SITE/S EVALUATION FOR ON-SI WASTEWATER

PINE GROVE DEVELOPMENT CORP.

SITE PLAN APPROVAL

.. SURVEY FOR ..

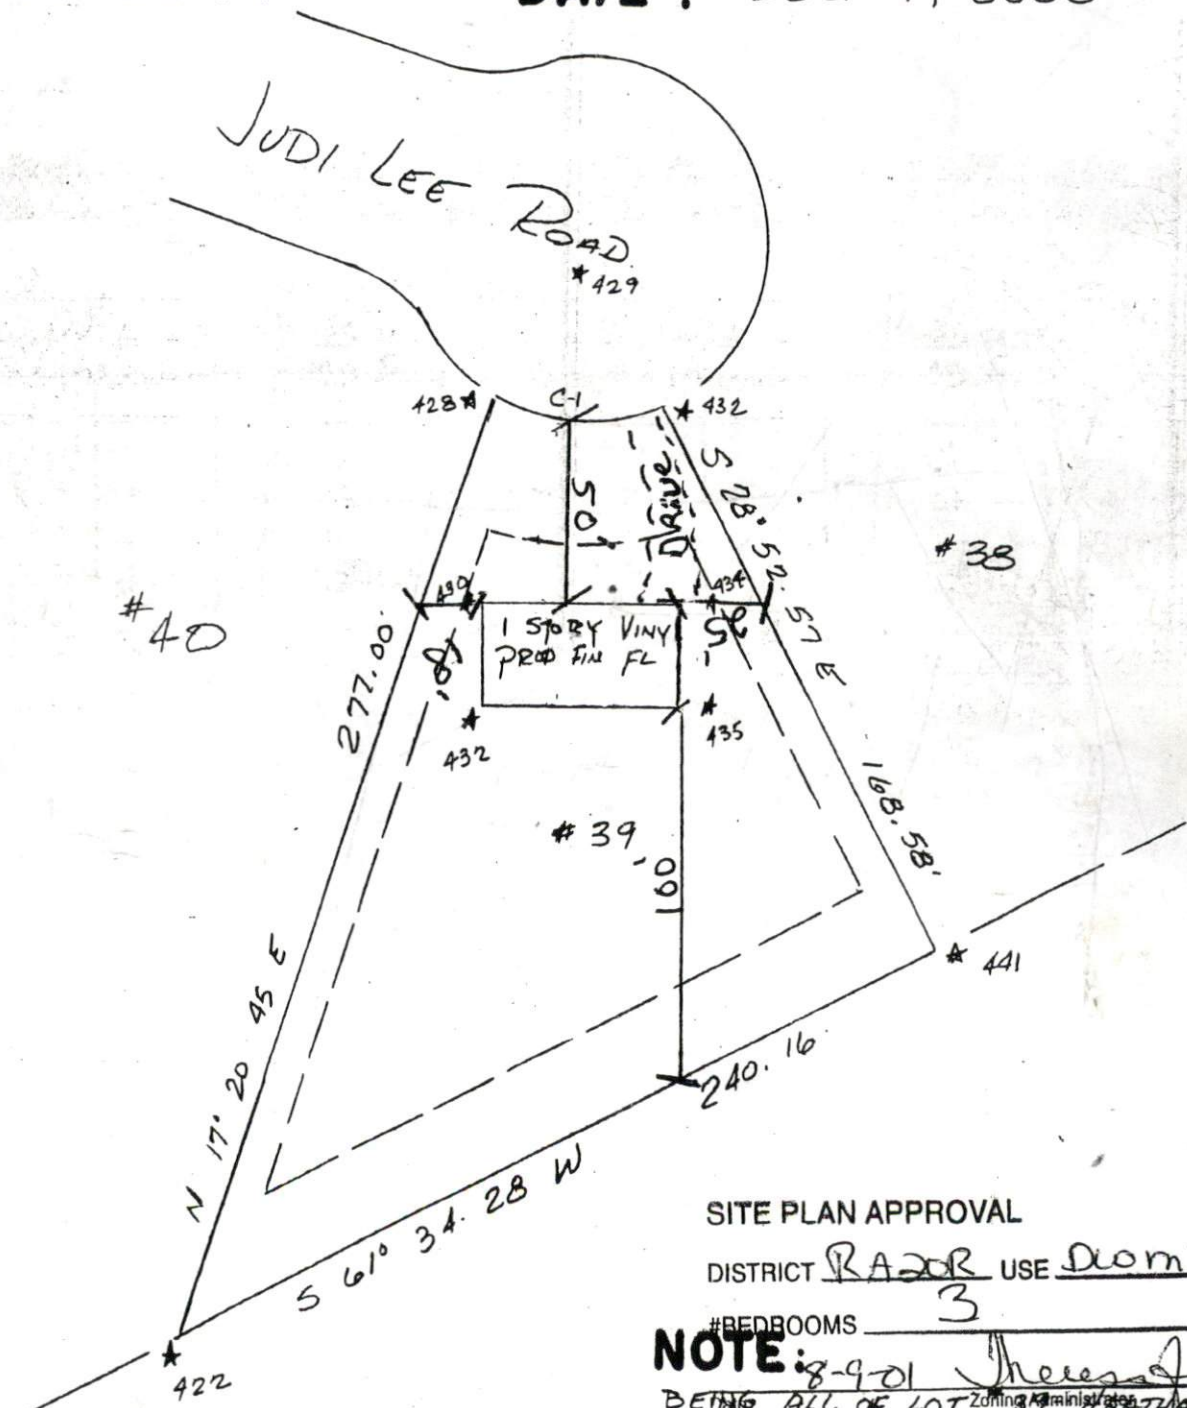
If the
hill is cut
Down to mud
Pump
will be
Asym

If too
much
is
cut
lot
may
be
lot
un
sustainable
